Addendum No. 001

Subject: Mechanical Plant Replacement Bid Package
Mechanical
SDP Contract No. B-045 (c) of 2017/18

Location: Arts Academy at Benjamin Rush
11081 Knights Road
Philadelphia, Pennsylvania 19154

DRAWING NO.
M501

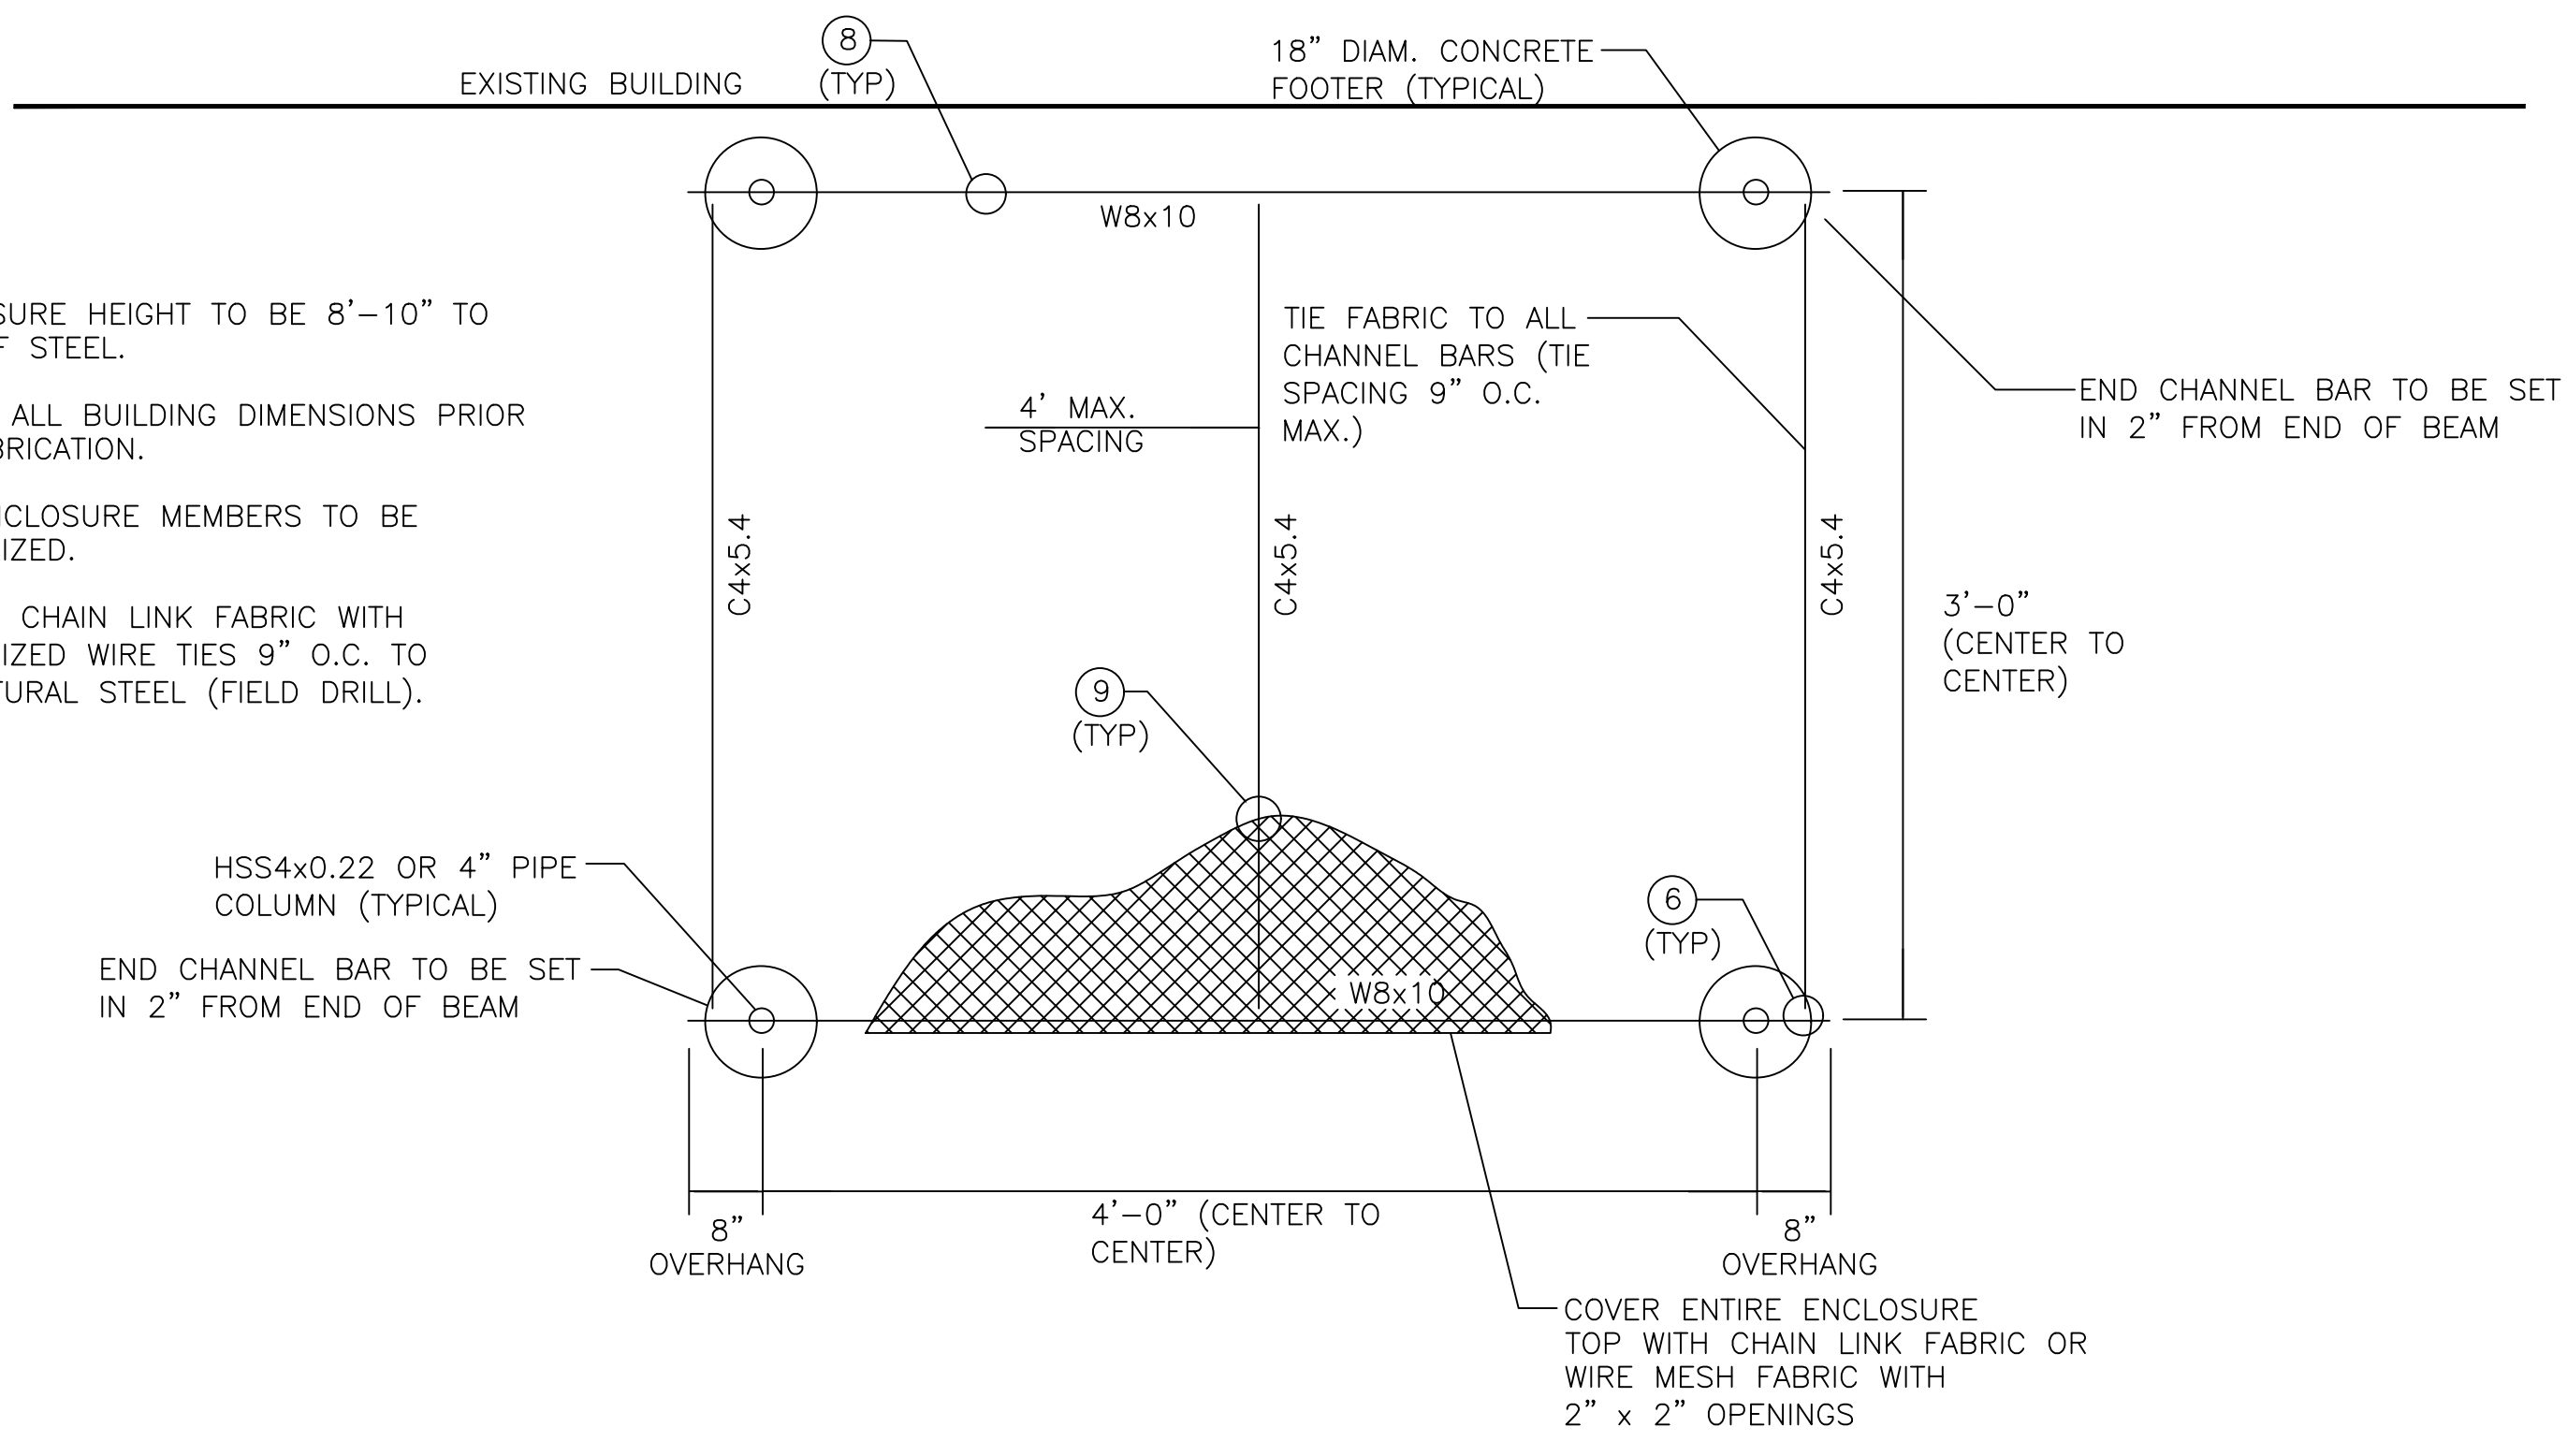
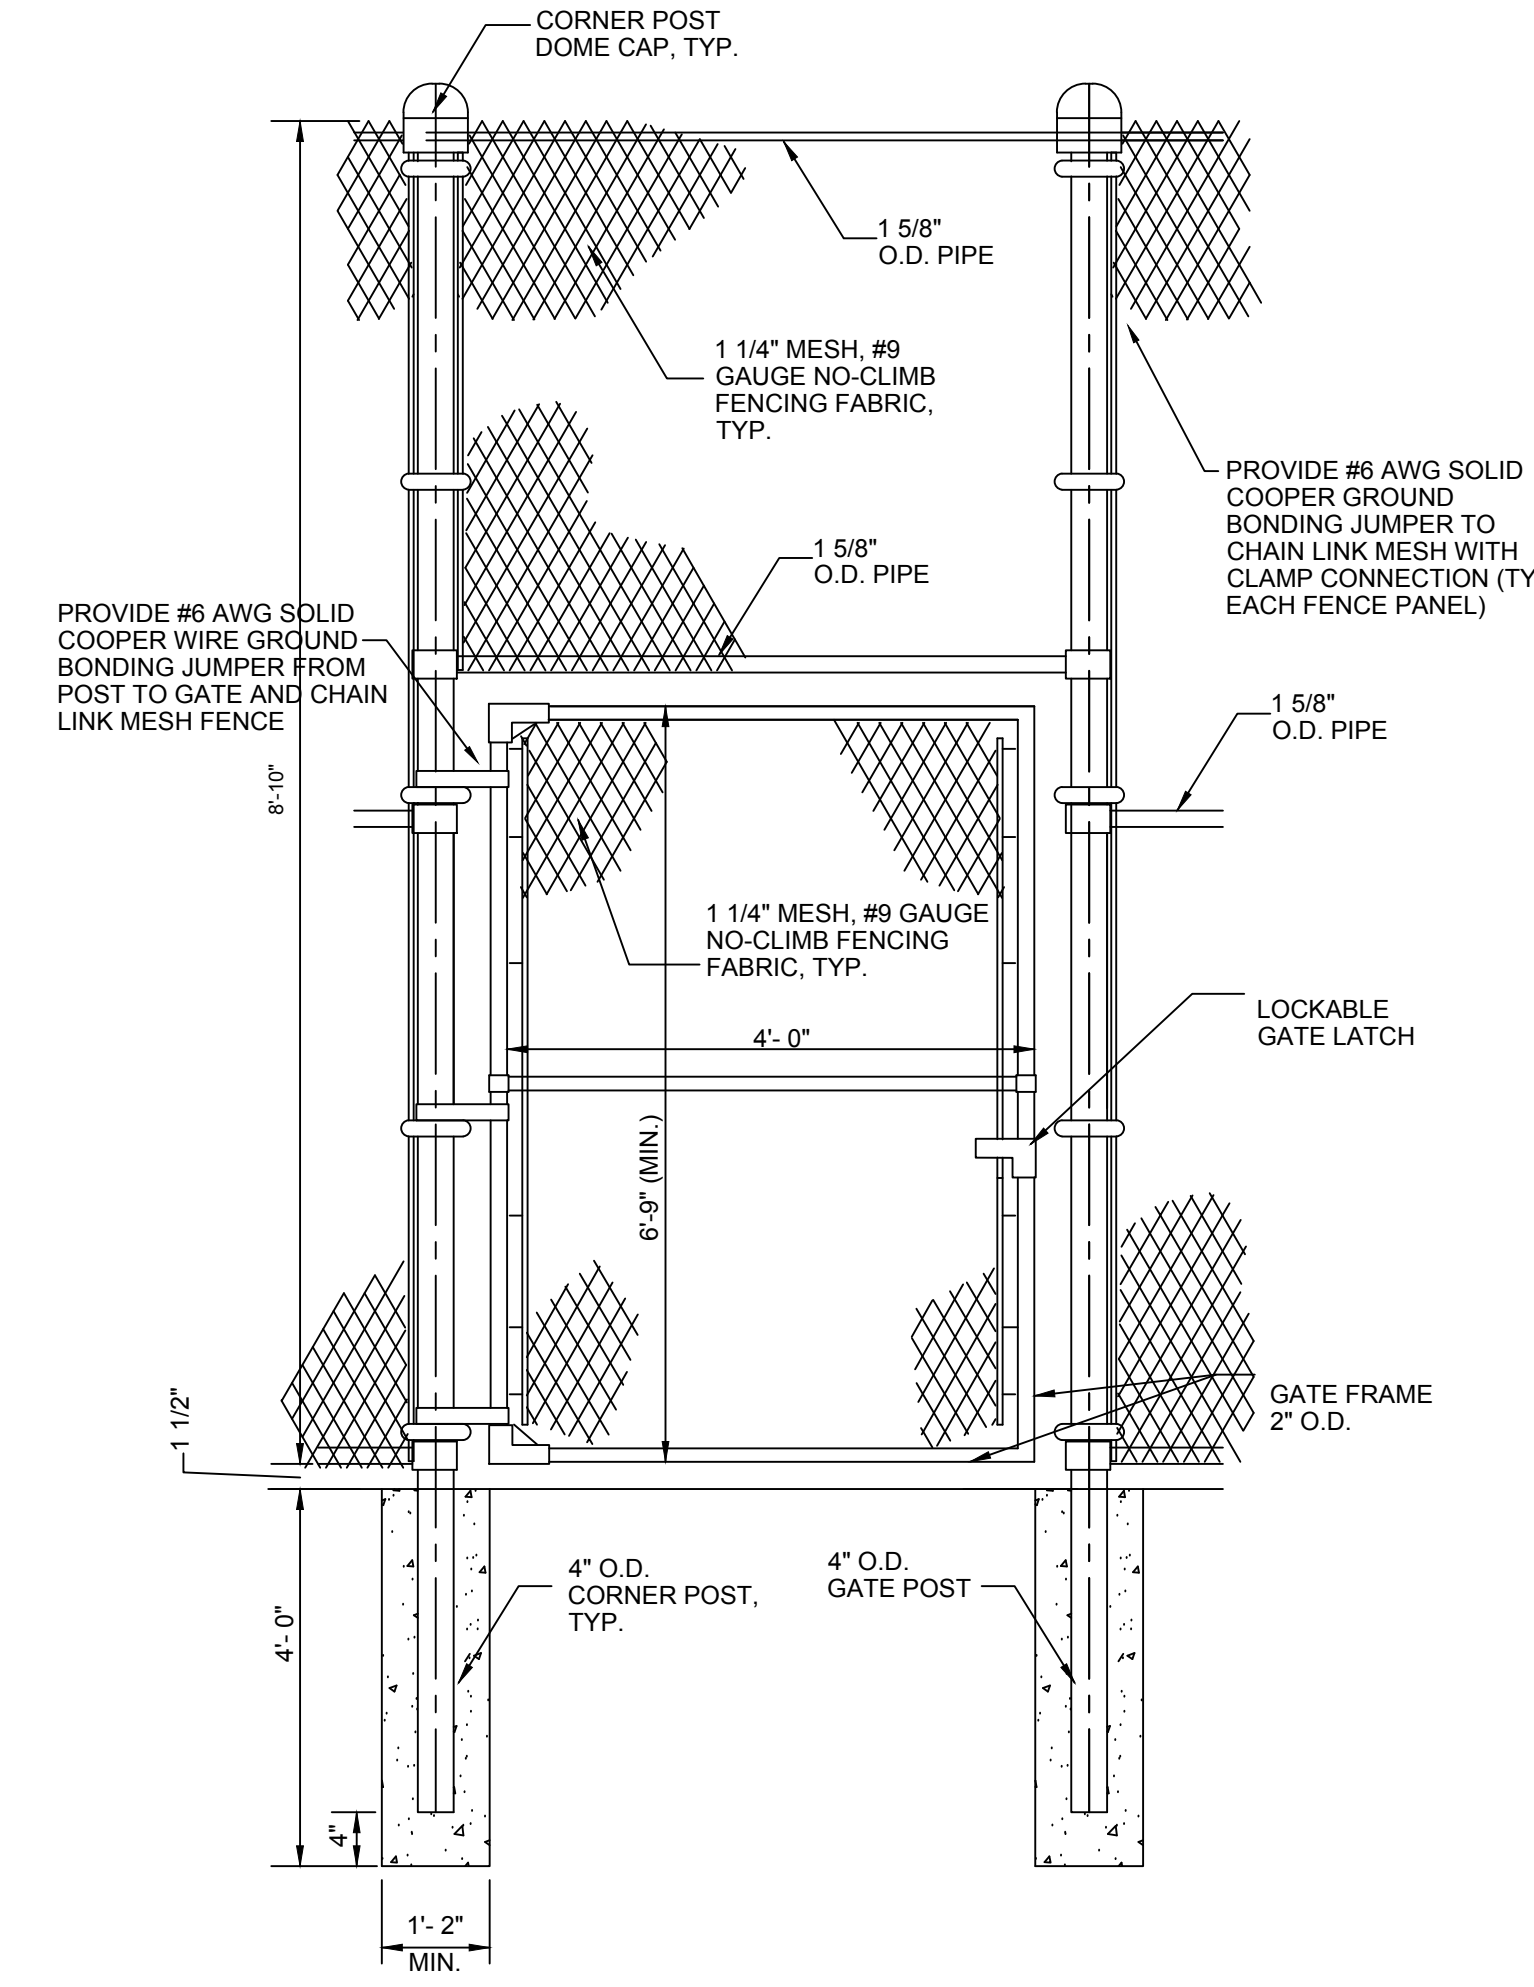
- 2.1.7** Added Sheet M501 – New detail sheet for chain link enclosure and bollard requirements.
- 2.1.8** Drawing revision E001 – Revised Life Safety Scope of Work Note 6 to indicate manufacturer of Fire Alarm system.

- NOTES:**
- ENCLOSURE HEIGHT TO BE 8'-10" TO TOP OF STEEL.
 - VERIFY ALL BUILDING DIMENSIONS PRIOR TO FABRICATION.
 - ALL ENCLOSURE MEMBERS TO BE GALVANIZED.
 - ATTACH CHAIN LINK FABRIC WITH GALVANIZED WIRE TIES 9" O.C. TO STRUCTURAL STEEL (FIELD DRILL).
